RE: Response to Internal Memo from John Lindgren Regarding Application for Transfer
Nos. 72674 and 74088, in the Name of Comore Development.

SUBJECT: Response to April 4th, 2008 IDWR memo from John Lindgren to Aaron
Marshal *Injury Assessment of Groundwater Impacts for Proposed Water Rights Transfer
Comore Loma Subdivision*"

Figure 1. Groundwater elevation contours (blue lines) and inferred flow directions (blue arrows) based on actual field measurements. The heavy black line represents the model boundary, which is setup as a no-flow condition.

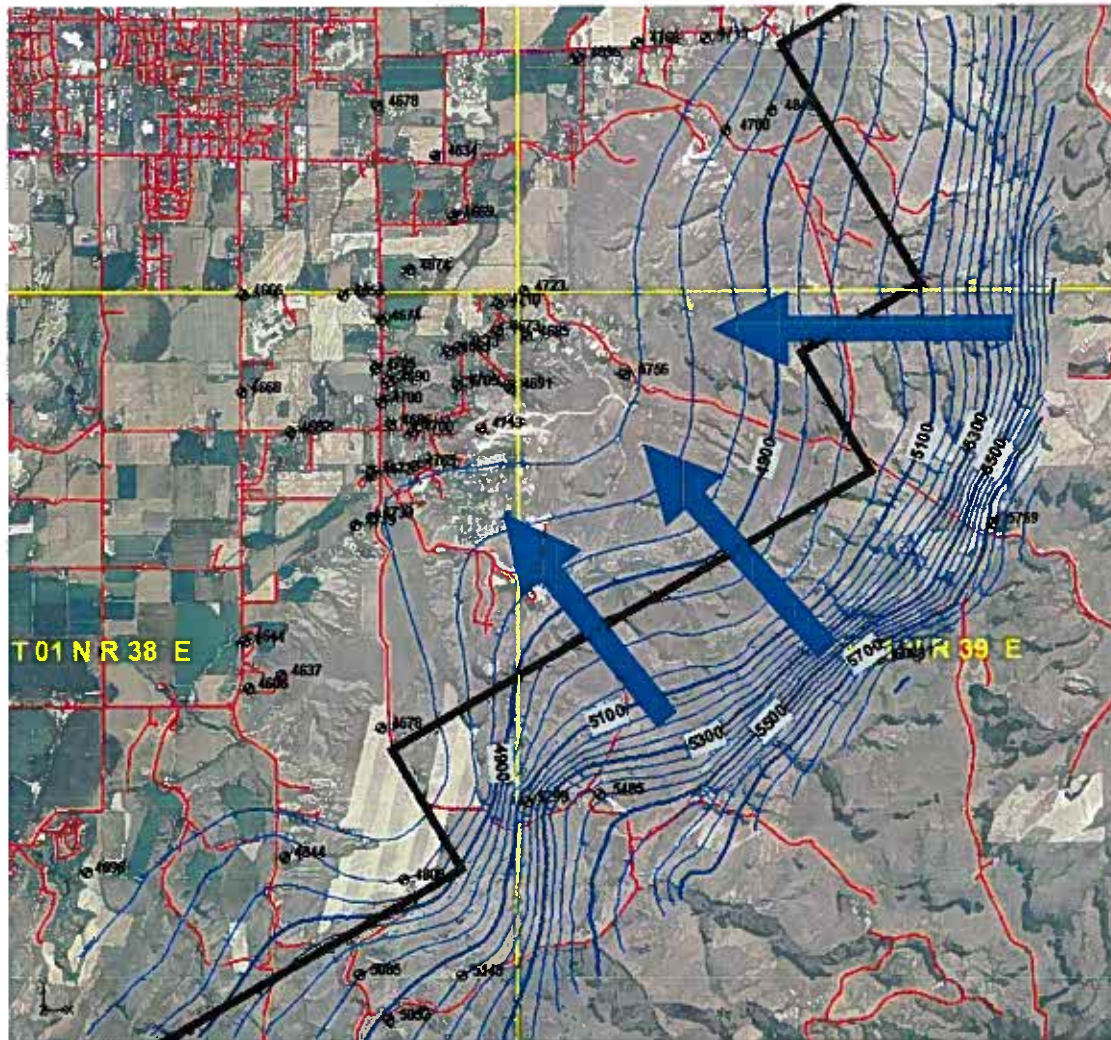
We show in our report that the water table in the vicinity of the Comore Loma property, based on measured water levels in wells, flows in a northwesterly direction, which is perpendicular to the model boundary. The ESPAM predicts a southwesterly flow direction parallel to the model boundary and perpendicular to the measured groundwater flow direction. We also document how the ESPAM water table elevation is 300 feet lower than the actual water table. This miss-match between the "calibrated" ESPAM and real data indicates either a serious flaw in the model "calibration" and/or a problem with the conceptual model used to build the numerical simulation. Figure 5 shows the groundwater map of the ESPAM and the flow direction and the water table map based on well measurements.

Figure 2. Location of model cells representing specified flux into the ESPAM. Approximate location of Comore Loma shown for reference. Reprinted from IWRRI Technical Report 06-002 (Cosgrove et al., 2006).

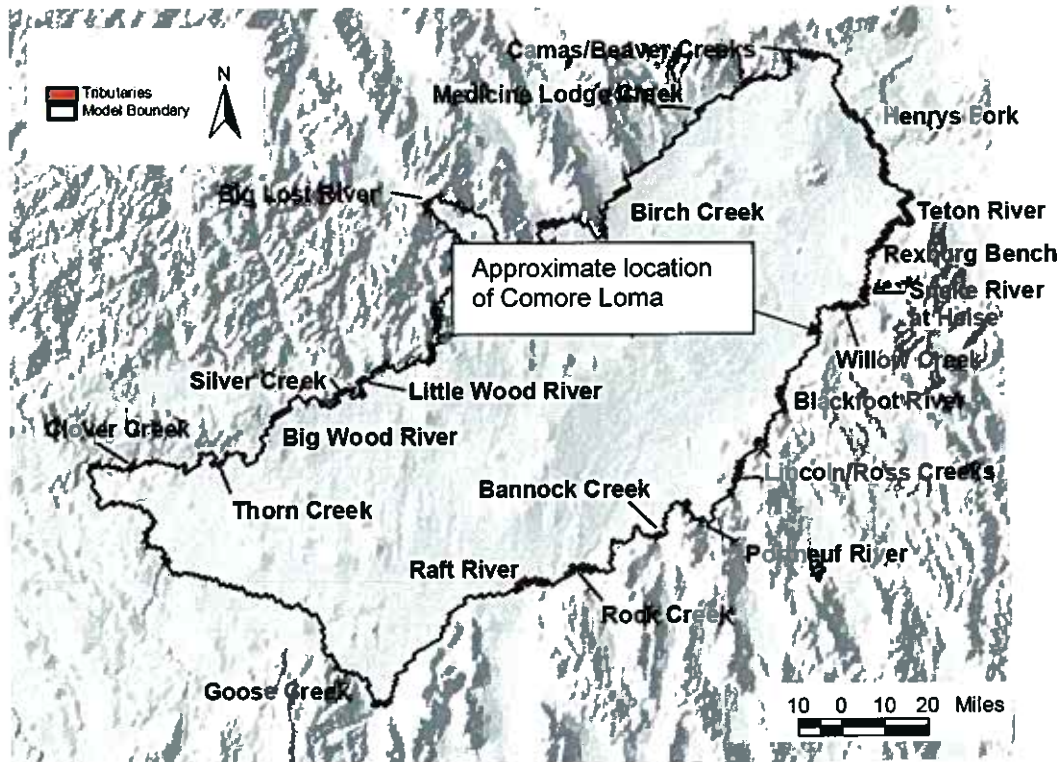
Mr. Lindgren's assertion that our report contends that the ESPAM does not include subterranean flow is true at the local scale only. We state that the ESPAM does not account for underflow from the mountain front to the east of Comore Loma, which it does not. However, we are confused as to how Mr. Lindgren construed this to mean that we said no underflow is represented anywhere in the ESPAM. It is well documented that there are specific areas at the boundaries of the model where underflow is tributary. As a matter of fact, we employed these same flux boundary conditions in our modeling runs using the ESPAM. The nearest location where underflow is specified in the ESPAM is nearly 10 miles away from Comore Loma. Figure 2 below is a reprint of Figure 22 from

IWRRI Technical Report 06-002 (Cosgrove et al., 2006), showing the locations of specified underflow. Figure 3 shows the specified flux cells near the Comore Loma property.

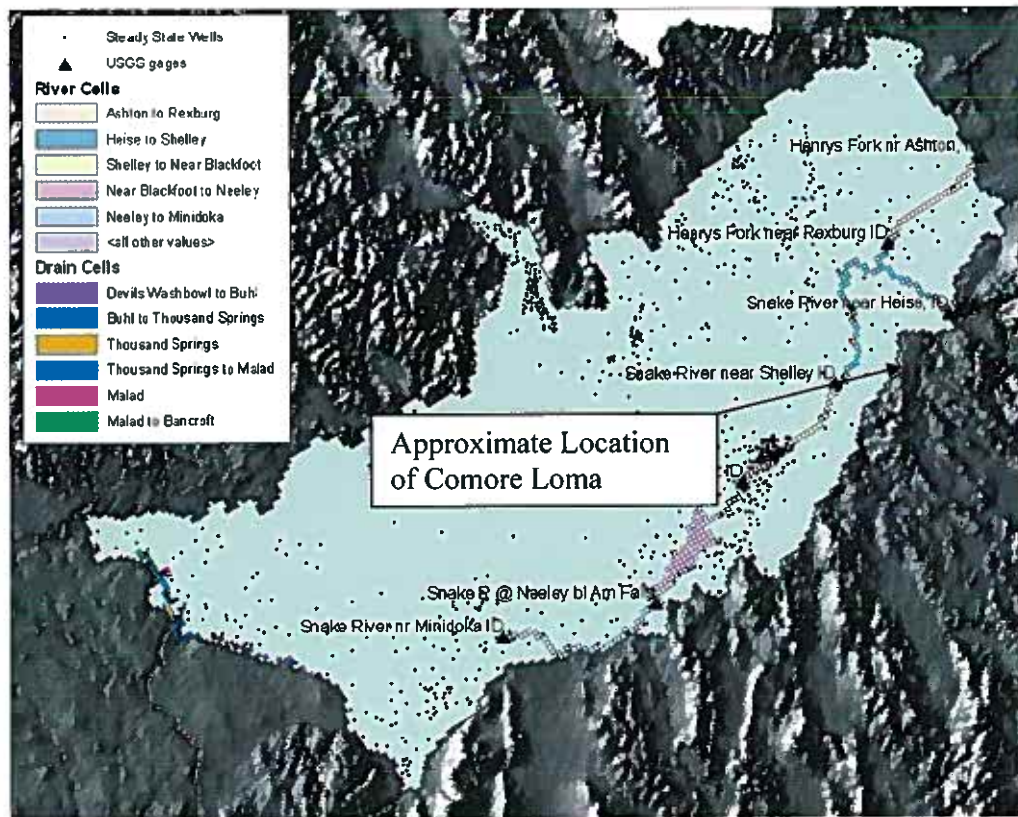
Again, Mr. Lindgren is overstating the merits of the ESPAM as a calibrated model, especially at the scale important for the Comore Loma Transfer. The ESPAM was calibrated at the scale of the model domain, some 11,000 sq miles, to water levels in about 1009 aquifer wells. This is very few wells at the scale of the aquifer and cannot possibly be rigorous enough for the purposes of the Comore Loma transfer, in fact, page 101 of the ESPAM report states "*the ESPAM is a regional model and is not intended for predictions of impacts to individual springs. A regional model is limited to replicating broad-scale heterogeneity in the physical system and cannot replicate localized heterogeneities.*" Figure 4 shows the locations of IDWR's calibration points for the steady-state version of the ESPAM (reprinted from Figure 55 in IWRI Technical Report 06-002). The nearest calibration point is over 10 miles away from Comore Loma.

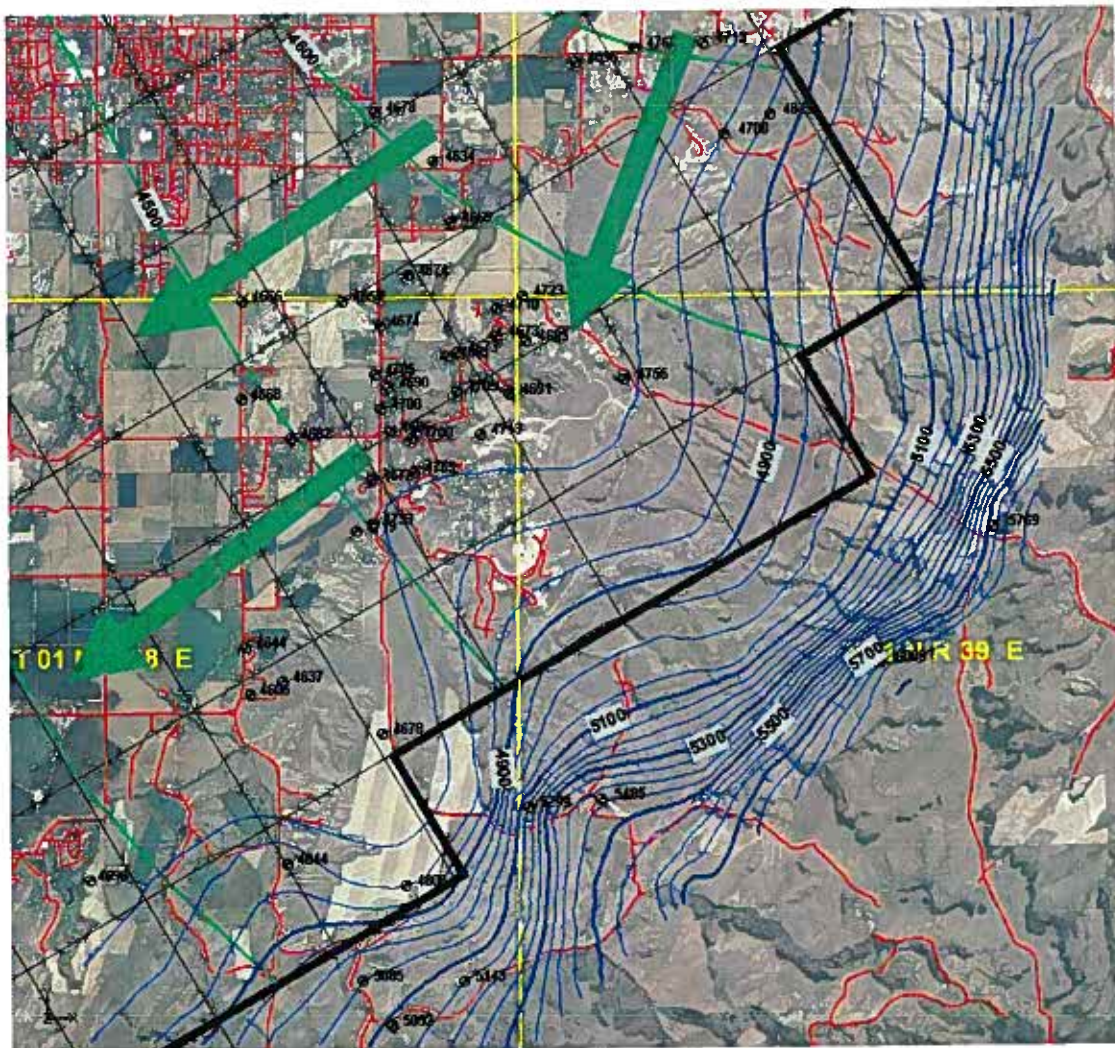
The mismatches between flow direction and water table elevation are serious and render the ESPAM nearly useless for the Comore Loma Transfer, but the problems could be corrected by simple modifications to the ESPAM. Consider Darcy's Law:

cell gives the area (A)) constant, increasing the flux (Q) across the boundary will force the gradient (dh/dl) to increase, thereby raising the predicted water levels along the model boundary. Notice that in order to increase the elevation of the ESPAM water table more flux must come from the mountain front to the east (just as we have been arguing all along).
